**Item 4.****Development Application: 5 Victoria Road, Glebe - D/2021/865**

File No.: D/2021/865

This report deals specifically with issues raised by the LPP at the 27 April 2022 meeting and the updated Clause 4.6 variation request.

Figure 20: Maximum height proposed to Dwelling 1, with the 6m height control depicted with red dashed lines

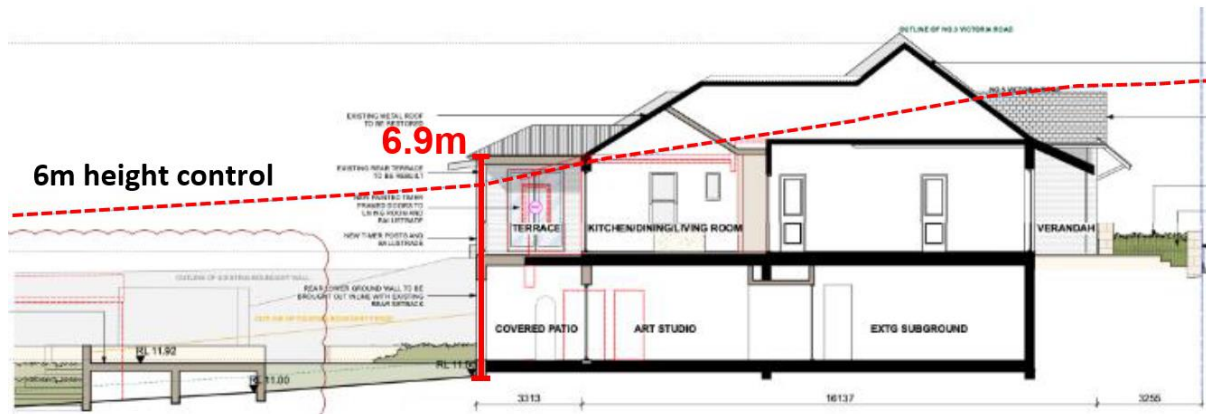
- 14. The site is subject to a maximum Height of Buildings control of 6m. The proposed development has a maximum height of 8.8m, consisting of the roof ridge of the new dwelling (Dwelling 2). The proposal comprises a 46% breach of the height standard.
- 15. It is noted that the existing building on site (Dwelling 1) has a maximum height of approximately 10m to the top of the roof ridge, and proposes alterations to the roof of the rear terrace awning that will result in a height of 6.9m, or a 15% breach of the height standard. See Figures 20 and 21 below demonstrating the maximum height breach of each dwelling.

Figure 21: Maximum height proposed to Dwelling 2, with the 6m height control depicted with red dashed lines

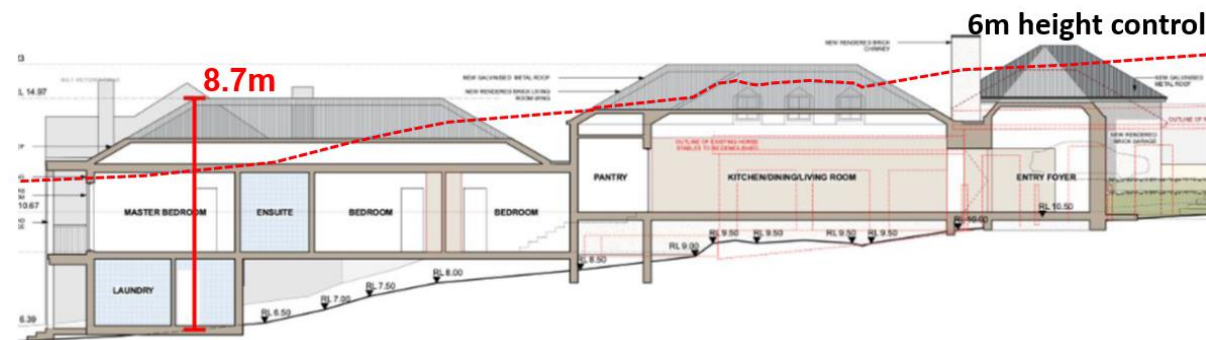
- (a) The height of the development is appropriate to the condition of the site and its context. Whilst at 46%, the variation cannot be considered minor, the height exceedance is not a result of the proponent attempting to accommodate an excessive amount of floor space within the building envelope or a reflection of overdevelopment of the site. Rather, the contravention of the height standard largely results from the design choice to employ a hipped, gabled roof to the new dwelling on site, protect healthy, significant trees adjacent to the site in Jubilee Park and minimise changes in levels.

**Figure 22:** Site plan depicting Dwelling 2 footprint, and tree protection zone of Jubilee Park trees shown with red dashed circles

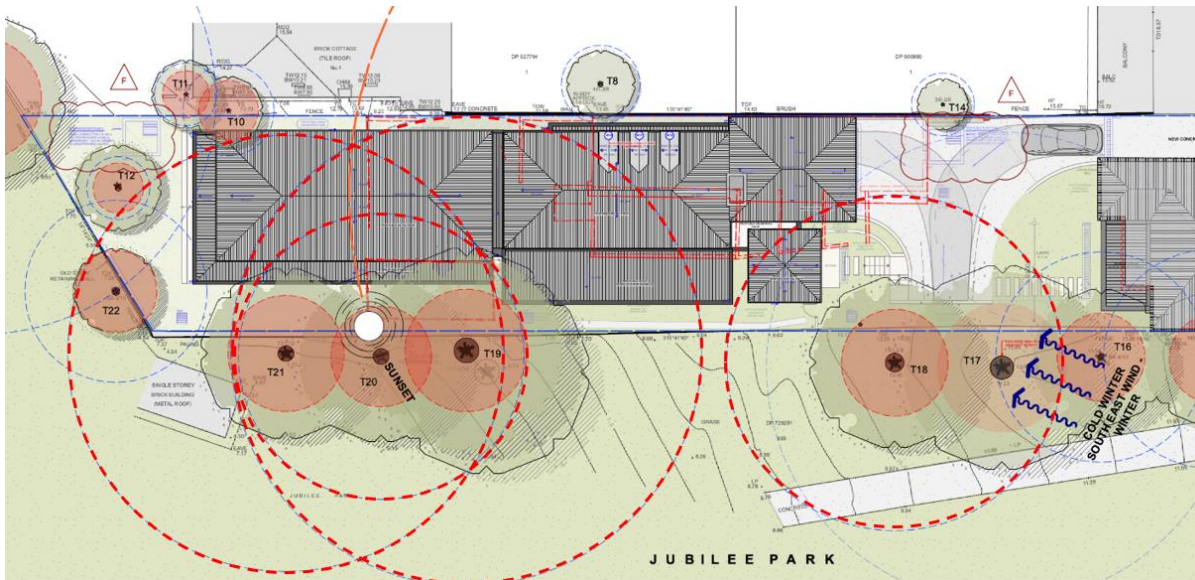
- (ii) The proposal has adopted tree sensitive construction methods to protect the health of significant trees within Jubilee Park immediately to the west, the extensive root systems of which would be located within the footprint of the proposed building known as Dwelling 2. This involves the use of a suspended concrete slab which provides generally good clearance above the natural ground level to bridge over tree roots and maintain the existing soil grade as much as possible below Dwelling 2, specifically the central pavilion. See Figure 22 below demonstrating tree protection zones that intersect across the entire footprint of Dwelling 2.

The proposed structures of Dwelling 2 will encroach into the tree protection zone of several trees in Jubilee Park by more than 10% (as identified in Figure 22 above) and could potentially impact the health of these trees. To reduce the impact to the trees and retain the trees in a viable condition, the footings of the proposed structures will need to be tree sensitive to bridge over significant roots that are located within this area. To minimise root loss in the tree protection zone of the trees, the footings of the proposed structures are to be pier and beam/suspended slab style footings to bridge over significant tree roots and minimise root loss. This construction technique contributes to the height exceedance, specifically the central pavilion of Dwelling 2. Lowering the height of the ground floor slab to comply with the height standard would have material impact upon the tree roots on site along with the stability and health of the trees and likely result in their removal. Such an outcome would be of detriment to the amenity and character of the area and be counter to the City of Sydney's policy to increase green canopy targets across the Local Government Area.
